Planning Commission

Wednesday, February 5, 2025

CLARKWOOD ESTATES PHASE 1 (PRELIMINARY OF 51.47 ACRES)

**Merged Document Report****Application No.: PL8294**

Preliminary Plat for Phase 1 CLARKWOOD ESTATES

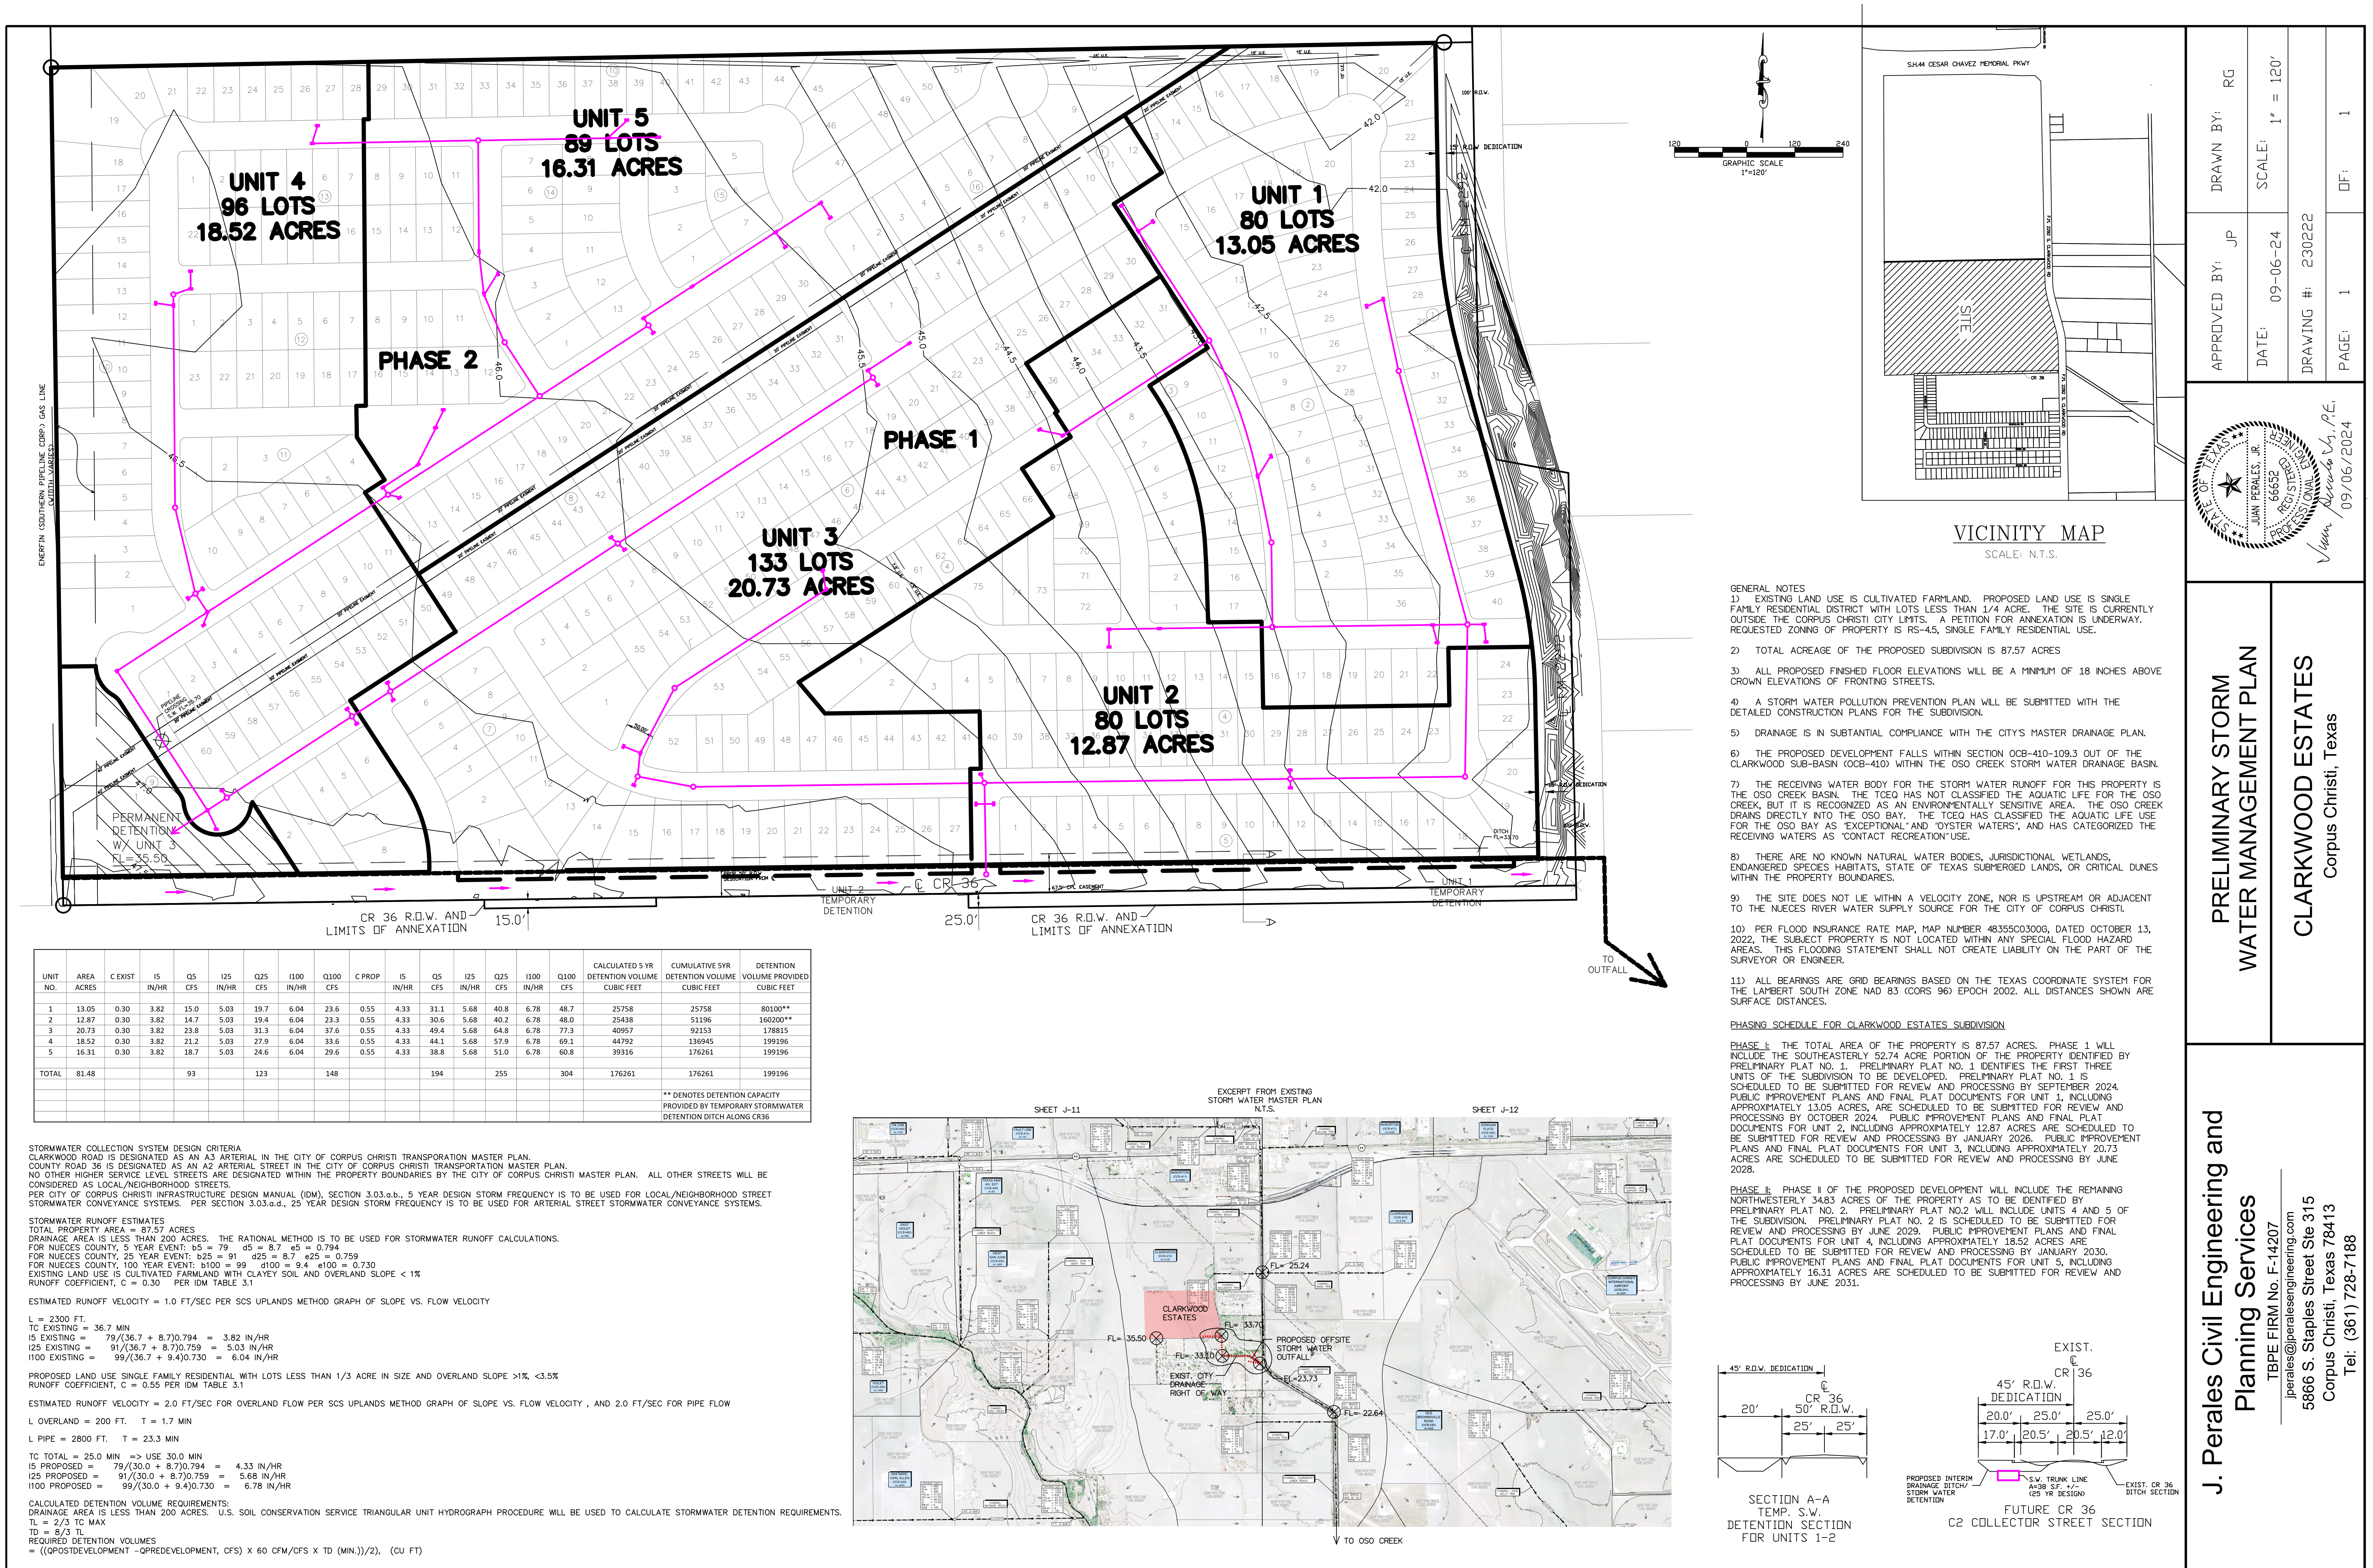
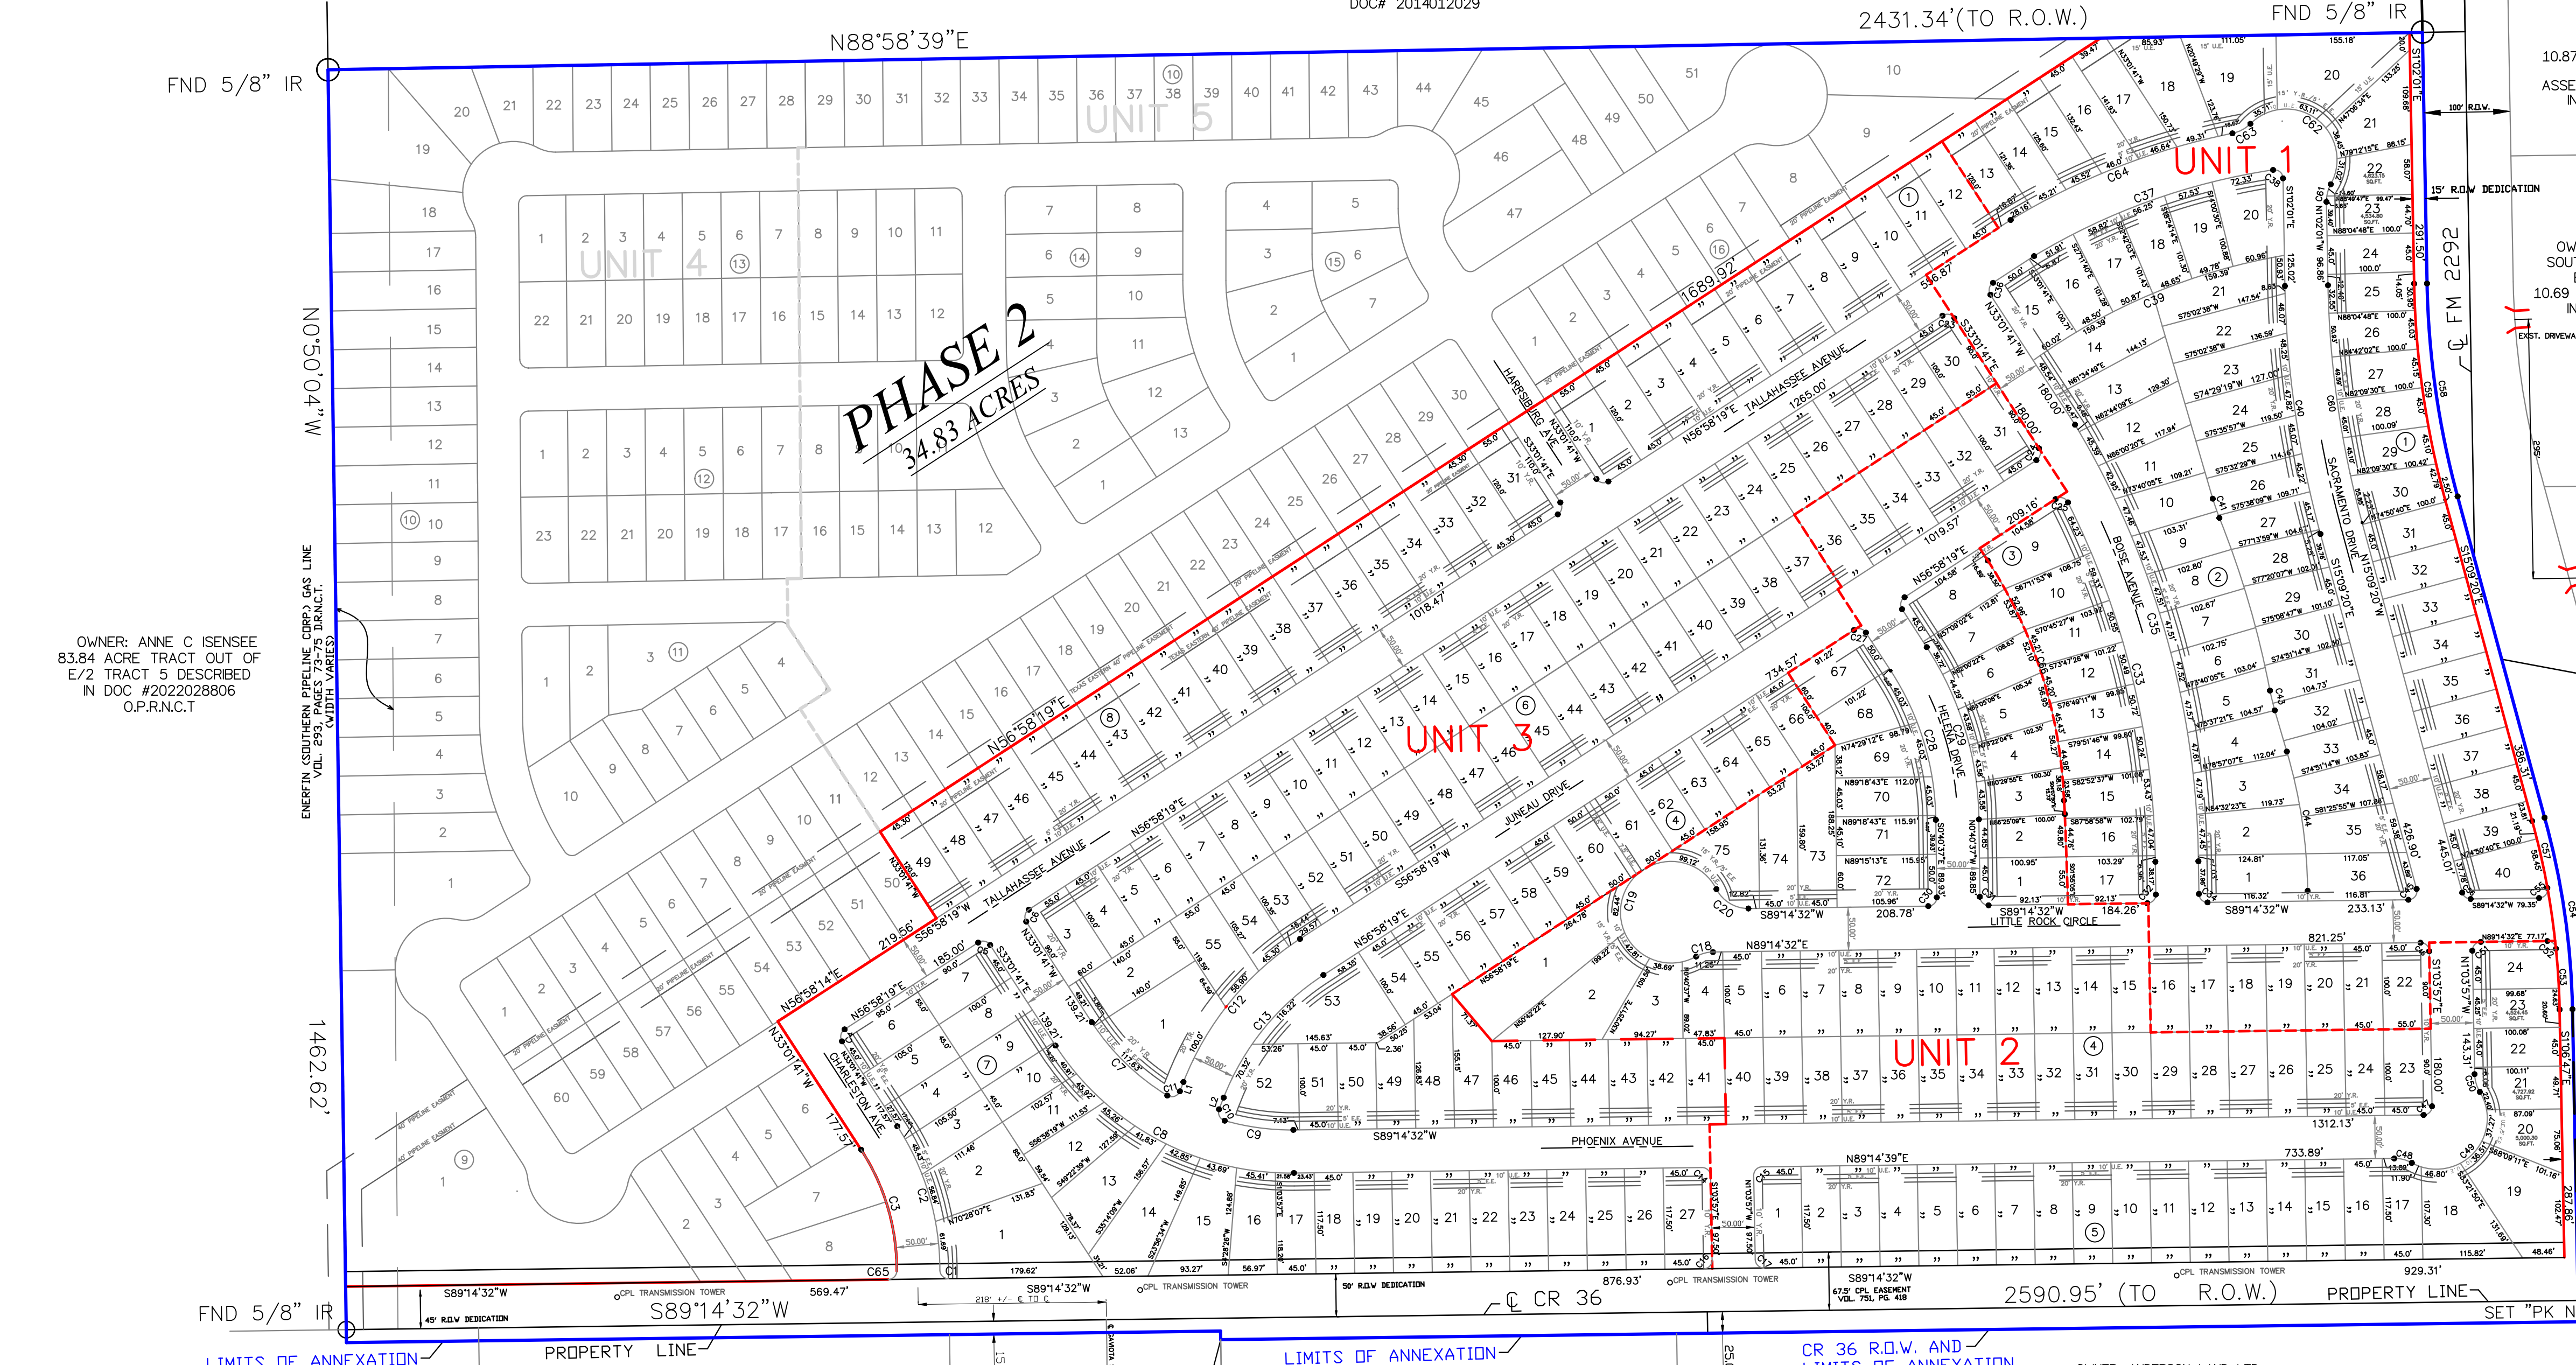
10	plat	Note	Andrea Fernandez : DS	Closed	Planning comment: Verify all lots are meeting RS-4.5 development standards (i.e. min lot width/area etc.) and provide general note.	
11	plat	Note	Melanie Barrera : DS	Closed	Nueces County Public Works comment: Underground storm sewer not allowed within county road 36 right of way.	
12	plat	Note	Melanie Barrera : DS	Closed	provide phasing estimated timeline (units shown not phases) for staff to review if proposed stormwater temporary/permanent infrastructure are appropriate, per UDC 3.7.4.; 3.7.3.A	
13	plat	Note	Melanie Barrera : DS	Closed	show all storm infrastructure on SWQMP, and easements.	
14	plat	Note	Melanie Barrera : DS	Closed	Nueces County Public Works comment: Recommend relocating the detention pond near the outfall structure at the south east corner of the development.	
15	plat	Note	Melanie Barrera : DS	Closed	Nueces County Public Works comment: Was upstream run-off considered into the design calculations for the detention pond and outfall run-off?

22	plat	Note	Andrea Fernandez : DS	Closed	CCRTA: This plat is not located along any existing or foreseeably planned CCRTA service route	
23	plat	Note	Andrea Fernandez : DS	Closed	Parks: No comments Dwelling units: 478 Fee: \$462.50 Total Due: \$221,075.00	
24	plat	Note	Andrea Fernandez : DS	Closed	AEP Transmission Comments: 1) Surveyor to reference volume and page number of our easement. 2) We would request a solid line across all plats on the south of the plat and not dashes. 3) AEP will protect 67.5' of our easement and will not allow any above ground improvements within our easement area.	
27	plat	Note	Andrea Fernandez : DS	Closed	Planning comment: Provide graphic scale	
30	plat	Note	Andrea Fernandez : DS	Closed	Planning comment: Provide document number for pipeline easement	
31	plat	Note	Andrea Fernandez : DS	Closed	Planning comment; Preliminary plat title should be Phase 1 instead of No. 1

Comment ID	Page Reference	Annotation Type	Author : Department	Status	Review Comments	Applicant Response Comments
32	plat	Note	Andrea Fernandez : DS	Closed	Planning comment: UTP designates CR 36 as A2. Update street section to required standards (ROW 100') Update: provide correct ROW width/Centerline	
35	plat	Note	Andrea Fernandez : DS	Closed	Public Works Streets Comments: •The developer shall be required to utilize the most stringent of sections per classification of roadway without a Geotech report validating the soil type. Please refer to Infrastructure Design Manual (IDM) when constructing pavement section. •Per IDM Table 6.3.5J, One coarse surface treatment/underseal would be required between the base and asphalt pavement.	
36	plat	Note	Andrea Fernandez : DS	Closed	Planning comment: Provide phasing schedule as per prelim plat template.	
37	plat	Note	Andrea Fernandez : DS	Closed	Nueces County Public Works comment: Does the street offset meet the minimum 125 ft distance at the Gaviota intersection?

38	plat	Note	Andrea Fernandez : DS	Closed	Nueces County Public Works comment: Existing ROW for CR 36 is 50 ft, 25 ft on center.	
39	plat	Note	Andrea Fernandez : DS	Closed	Nueces County Public Works comment: CR 36 ROW at San Juan Park is 25 ft on the north half of the road. There is no ROW adjacent to San Juan Park.	
40	plat	Note	Andrea Fernandez : DS	Closed	Nueces County Public Works comment: There is only 40 ft ROW fronting San Juan Addition #3.	
41	plat	Note	Andrea Fernandez : DS	Closed	Nueces County Public Works comment: There is no dedicated ROW west of San Juan Addition #3	
42	plat	Note	Andrea Fernandez : DS	Closed	Nueces County Public Works comment: Review existing ROW for San Juan Addition #3 to verify that the city's arterial requirements can be met in the future UPDATED: See comment #52	
44	plat	Note	Andrea Fernandez : DS	Closed	Traffic comment: 1Plat: Show Driveways on east side of FM 2292 and label intersection offsets

48	plat	Note	Andrea Fernandez : DS	Closed	<p>Planning comment: Provide approval letter for access point onto TxDOT ROW prior to being placed on PC agenda</p> <p>Updated: Pending approval letter</p> <p>UPDATED 1/28: Approval letter to be provided at final plat stage for relvant units.</p>	
50	plat	Note	Andrea Fernandez : DS	Closed	Planning comment: Label remaining acreage/units as phase 2	15

Comment ID	Page Reference	Annotation Type	Author : Department	Status	Review Comments	Applicant Response Comments
51	plat	Note	Bria Whitmire : DS	Closed	Verify ROW dimensions. On proposed CL to Proposed North ROW Line, there is 32.5 ft, however below it has 20.5'+11'+5'+1' = 37.5'? Clarify.	
52	plat	Note	Andrea Fernandez : DS	Closed	Traffic Comment 10/15/2024: CR 36 is an A2 in the UTP, which requires 100' of ROW per UDC Table 8.2.1.C. Provide such that there is 50' of ROW on your side from the CL along CR 36.	
53	plat	Note	Andrea Fernandez : DS	Closed	Planning: Confirm limits of annexation shown match with annexation ordinance going to city council.	
25	utility	Note	Mikail Williams : WTR	Closed	Water construction is required for platting (UDC 1.2.1.D & 8.2.6; Water Distribution Standards).	
26	utility	Note	Mikail Williams : WTR	Closed	CCW will review the proposed utilities when the Public Improvement Plans are submitted.
